ARCHITECTURAL REVIEW BOARD STAFF REPORT

Project #/Name	ARB-2021-117: Overlook Hotel Initial Site Plan
Review Type	Second Review of an Initial Site Plan and Architectural Design
Parcel Identification	07800-00-00-073A7
Location	The south side of Rt. 250 East approximately 250’ west of the Hansen Rd./Rt. 250 intersection (See Figure 1.)
Zoned	Planned Development Mixed Commercial (PDMC), Entrance Corridor (EC)
Owner/Applicant	WS Four LLC/Design Develop LLC (Kevin Schafer)
Magisterial District	Rivanna
Proposal	To construct a four-story hotel in addition to associated site improvements.
Context	The subject property is comprised of a single vacant parcel. Another vacant parcel is adjacent to the west. The area is characterized by a mix of residential and commercial development (Figure 1).
Visibility	The proposed development will be readily visible from the Entrance Corridor.
ARB Meeting Date	February 7, 2022
Staff Contact	Khrist Taggart

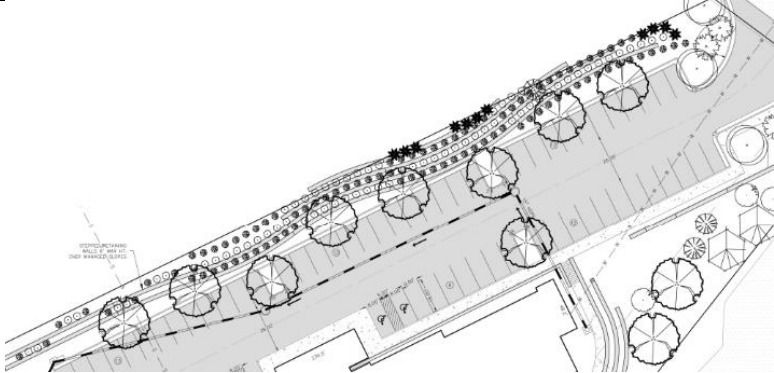
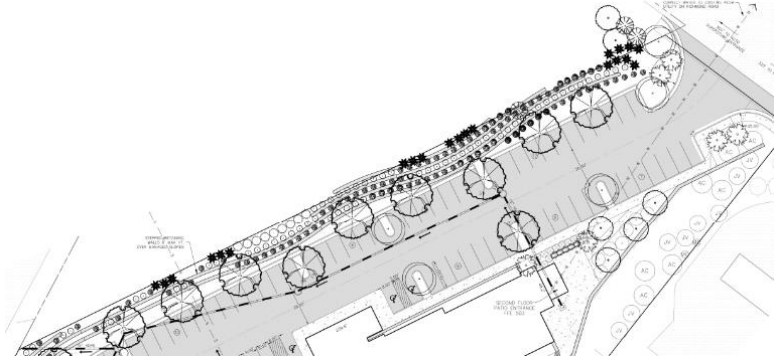
REF	GUIDELINE	RECOMMENDATIONS 11/15/2021	ISSUES 2/7/2022	RECOMMENDATIONS 2/7/2022
	GENERAL GUIDELINES			
	<i>Purpose, Compatibility with the character of the Entrance Corridor</i>			
1	The goal of the regulation of the design of development within the designated Entrance Corridors is to ensure that new development within the corridors reflects the traditional architecture of the area. Therefore, it is the purpose of ARB review and of these Guidelines, that proposed development within the designated Entrance Corridors reflect elements of design characteristic of the significant historical landmarks, buildings, and structures of the Charlottesville and Albemarle area, and to promote orderly and attractive development within these corridors. Applicants should note that replication of historic structures is neither required nor desired.	Revise the architectural design to make the northern tower address the EC street and possibly further conceal the eastern retaining walls. Adjust the placement, height, materials and detailing of the tower elements to achieve a more cohesive overall appearance for the building. The ARB does not recommend approval of eliminating the setback requirement; however, an alternate design that does not include a setback but establishes a cohesive overall appearance for the building can be considered.	The building has been revised to achieve a more coordinated design and a more appropriate appearance for the EC. The two bays of windows and canopy over a new patio on the northern tower provide a face to the EC and improve the scale of the form. Greater coordination throughout the building design is provided by: brick used at the ends, center and intermediate bays; brick across the base; and dark metal for cornices, center roof, and end and center canopies. The mass of the building is broken down by a switch from hipped roofs to flat roofs with cornices and bays of alternating heights and materials. However, material samples have not been provided for review yet. Human scale as seen from the street is enhanced by alternating materials, brick detailing, and the canopies. The grading in the area surrounding the end tower has also been revised to give the appearance, as viewed from the EC, of a three-story building. As indicated in the History section above, the special exception to eliminate the setback requirement is no longer need. Significant revisions to building design and form were made to address the setback issue, but they were also needed to establish an appropriate appearance for the EC, regardless of setback requirements. The revisions made to the design of the tower, combined with the revised grading, sufficiently establish building design and scale that are appropriate for the EC.	Provide samples for all material and colors with the final site plan submittal.

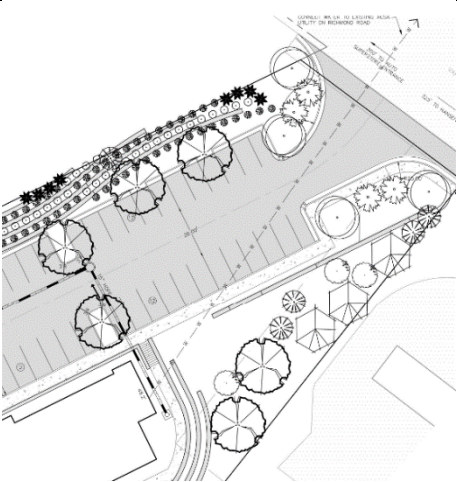
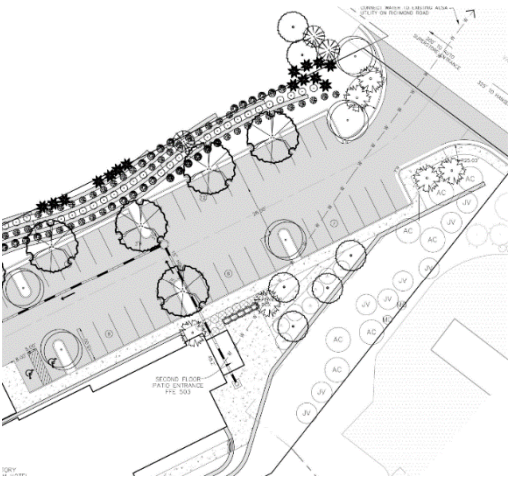
9	Building forms and features, including roofs, windows, doors, materials, colors and textures should be compatible with the forms and features of the significant historic buildings in the area, exemplified by (but not limited to) the buildings described in Appendix A [of the design guidelines]. The standard of compatibility can be met through scale, materials, and forms which may be embodied in architecture which is contemporary as well as

traditional. The replication of important historic sites in Albemarle County is not the objective of these guidelines.			
10	Buildings should relate to their site and the surrounding context of buildings.			
12	Architecture proposed within the Entrance Corridor should use forms, shapes, scale, and materials to create a cohesive whole.			
13	Any appearance of “blankness” resulting from building design should be relieved using design detail or vegetation, or both.			
11	The overall design of buildings should have human scale. Scale should be integral to the building and site design.			
14	Arcades, colonnades, or other architectural connecting devices should be used to unify groups of buildings within a development.	None.	A single building is proposed, so a connecting device is not necessary.	None.
15	Trademark buildings and related features should be modified to meet the requirements of the Guidelines.	None.	While revisions have been made to forms and material in the building design, the core design is still consistent with examples of WoodSpring Suites buildings in other locations.	None.
